### **EQB Staff Summary of Selected Scoping Comments**

The following list is an EQB staff summary of major public comments on the scope of the environmental impact statement for the Xcel Energy 345/115-kV high-voltage transmission line in Southwest Minnesota:

### High-Voltage Transmission Line and Substation Site Screening Criteria

### Rejected Route Segments

Figure 3

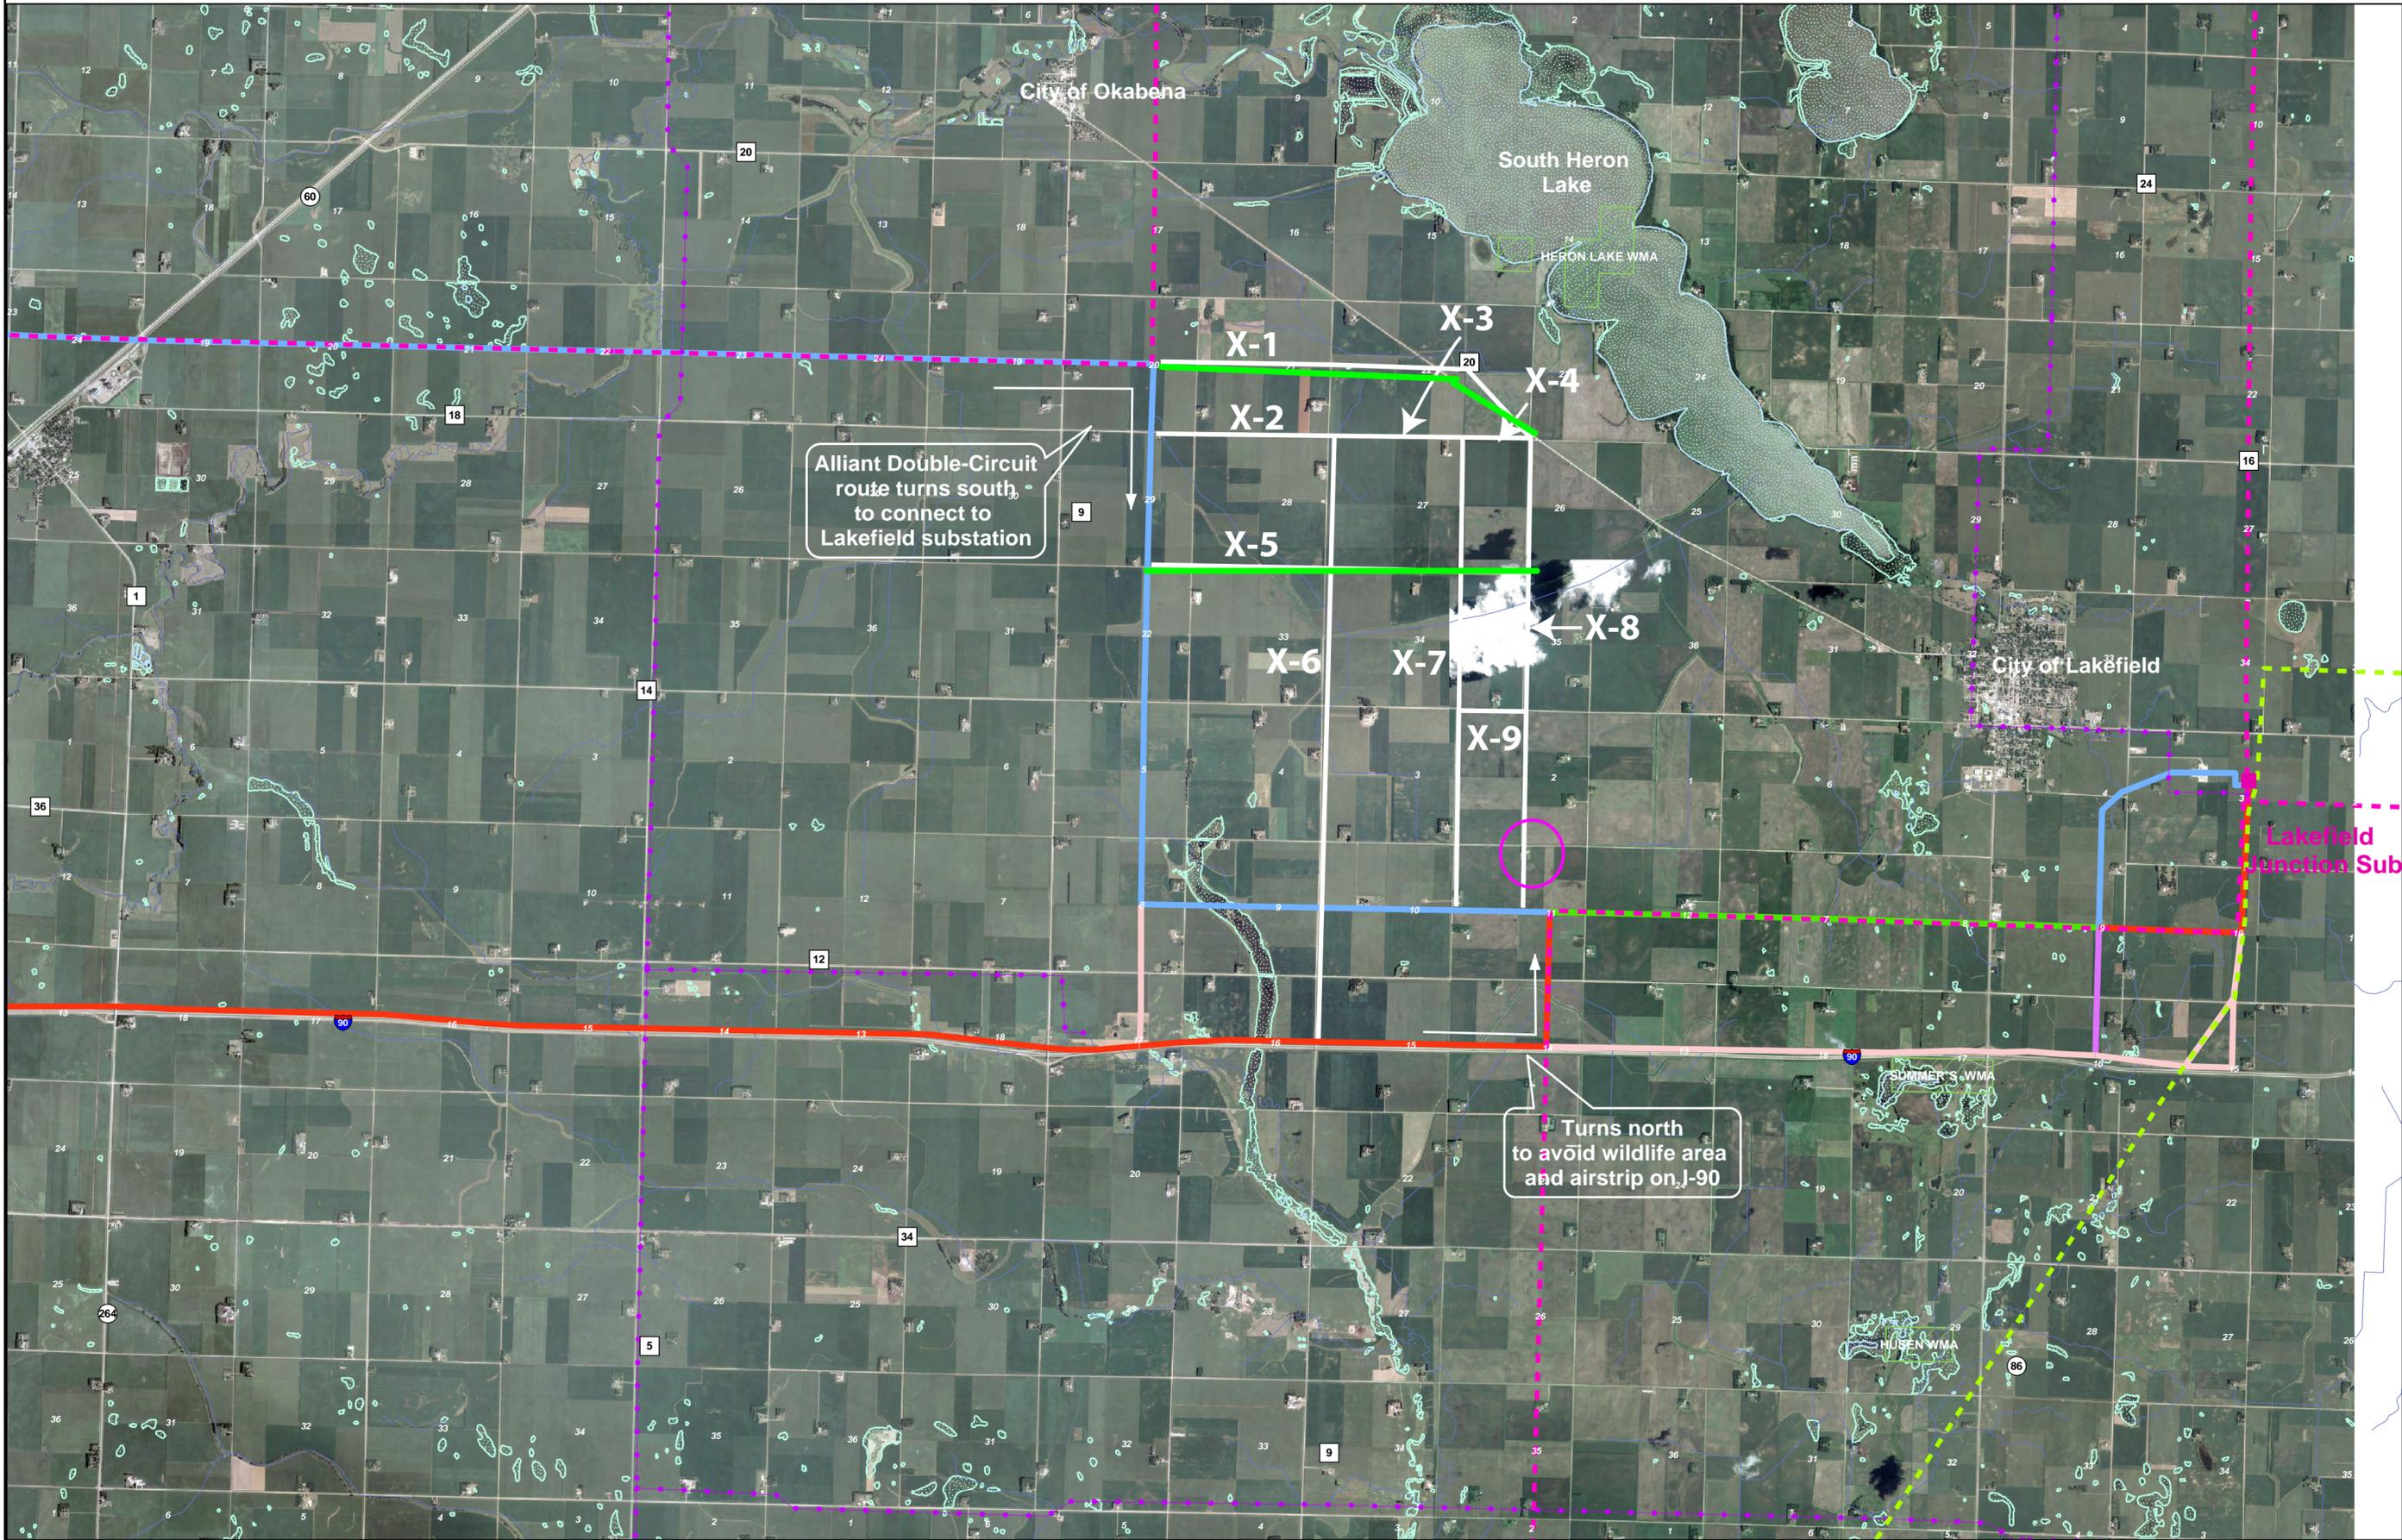
The following potential routes for the 345-kilovolt line were rejected (Figure 3):

X1. This route is rejected because it is too close to the South Heron Lake Wildlife Management Area, which is an important waterfowl flyway and landing area, according to local citizens and the Department of Natural Resources. High-voltage transmission lines have been shown to cause injury and fatalities to waterfowl and migratory birds due to collisions. Although mitigation is possible, other route segments in the area are further from residences and further from South Heron Lake.

X2 through X7. These routes are rejected because there were other route segments available that avoided more residences, required fewer turns, are shorter. Segment X4 was also rejected because it is close to the South Heron Lake Wildlife Management Area (See X1).

X8. This five-mile long segment, which would connect routes to the east to the existing 161-kV right-of-way, is rejected because the northern section is close to South Heron Lake, and because it would come within 100-feet of two residences on the half-section line and close to several others. The additional route-segment in the area that will be studied in the EIS, Segment J2, does not come as close to any existing residence.

X9. This short crossing-segment is rejected because it would require the line to be built across the roadway from a residence, and other alternatives in the area avoided coming that close to a residence.

Figure 5

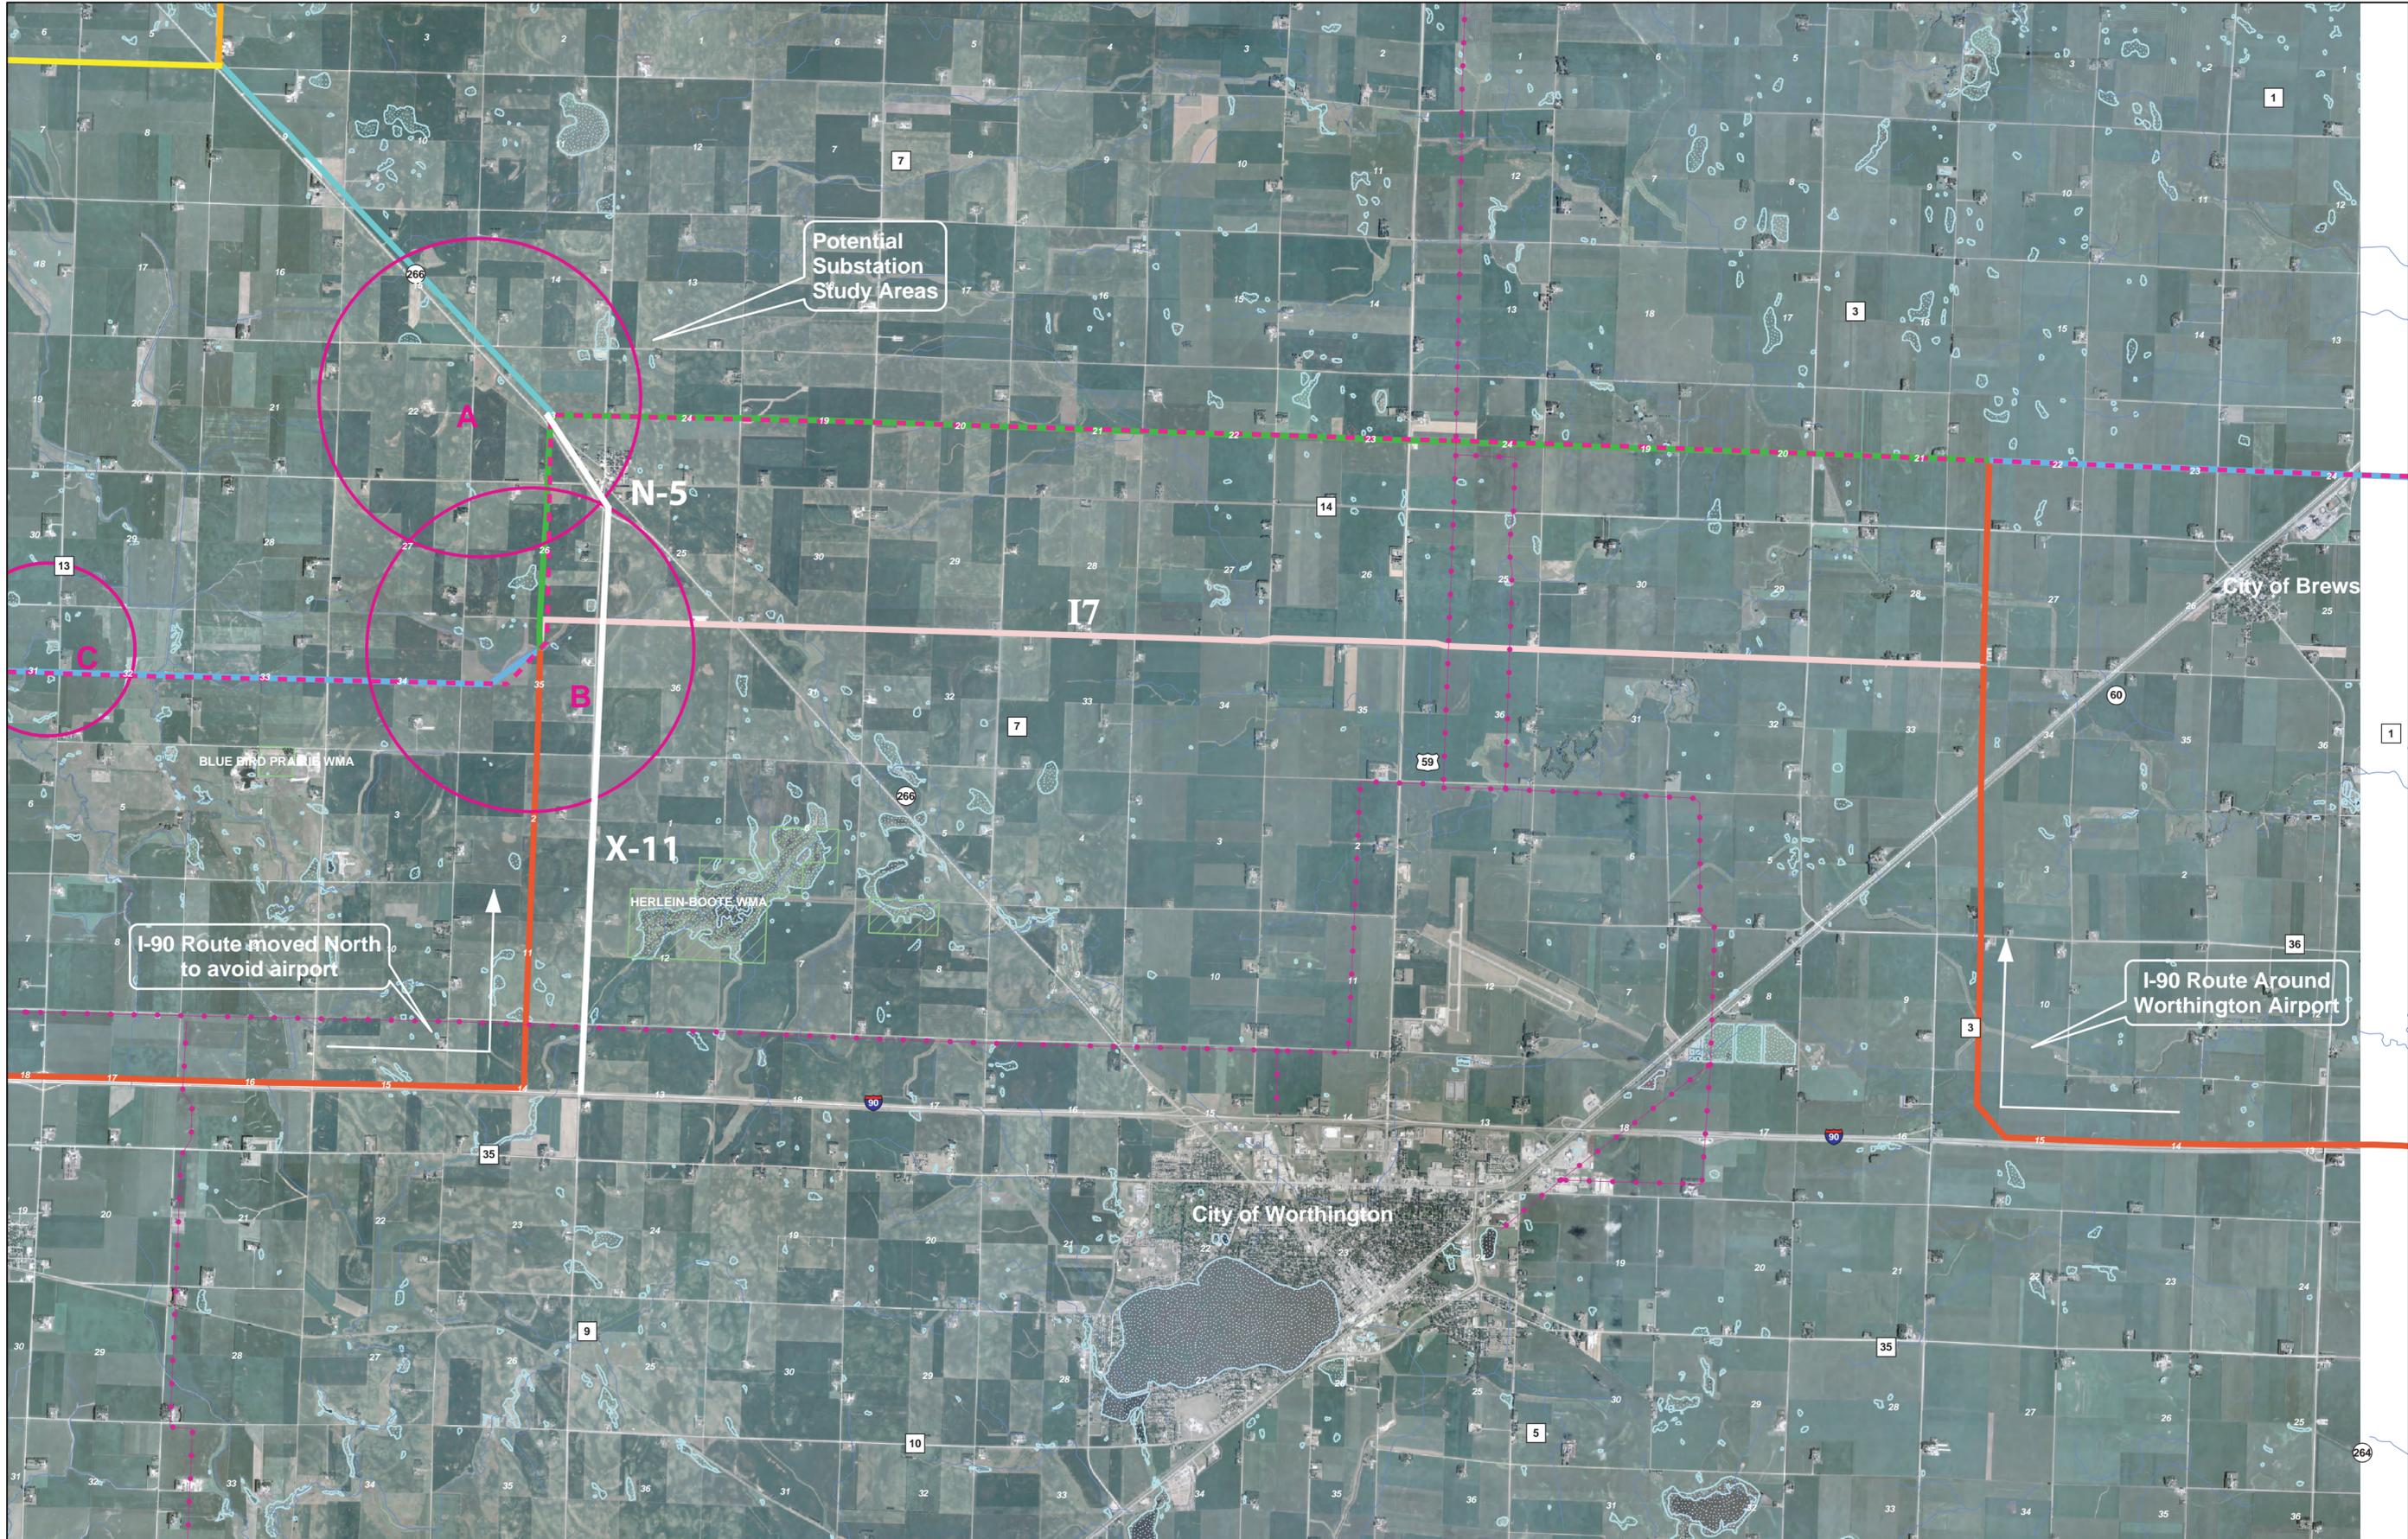
X-11. (Figure 5) This segment, which uses County 9 as a north-south segment of the I-90 route instead of the half-section line, was rejected because it would come close to more adjacent homes than Xcel Segment I-6. However, the EIS will evaluate using the northern part of this route-segment (Segment N-5) for the 115-kV line because it may be required to connect into a substation located in Substation Area B in the Xcel Energy application.

I7. (Figure 5) Most of Xcel's route I7 will not be further considered as a potential route for the proposed transmission line because it would require new right-of-way and the other route option in the area does not. (The other option is Xcel Segment T10, which would be a double-circuit with the existing 161-line just to the north.) The westernmost part of Segment I7, however, is located within Substation Area B and will be evaluated in the EIS as a potential alternative route for the 115 kV line to connect from a substation to the potential 115-kV routes in the area.
